Origination Form

Name:	Dino Jameson	Specification Number:	120-1, 120-2, 120-5.1, 120-6.2, 120-6.4, 120-7.2, 120-8.1, 120-8.2, 120-8.4, 120-8.5, 120-8.6, 120-9.2, 120-9.4, 120-10.1, 120-10.2, 120-10.3, 120-10.4,120-10.5,120-10.6, 120-10.7, 120-11, 120-12, 120-13
Email:	dino.jameson@dot.state.fl.us	Associated Specs:	None
Date:	2024-06-27T23:58:02Z	Verified:	VERIFIED

EXCAVATION AND EMBANKMENT (REV 6-27-24)

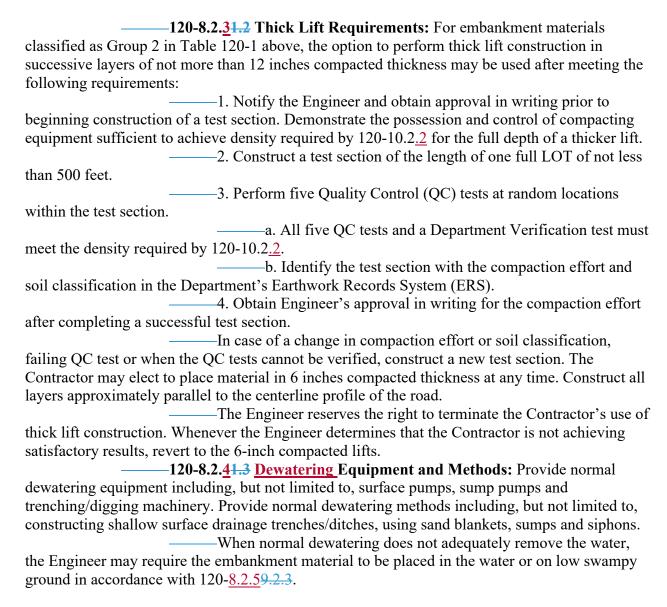
——120-8.2.21.1 Maximum Compacted Lift Thickness Requirements: Construct the embankment in successive layers with lifts up to a maximum listed in Table 120-1 below based on the embankment material classification group.
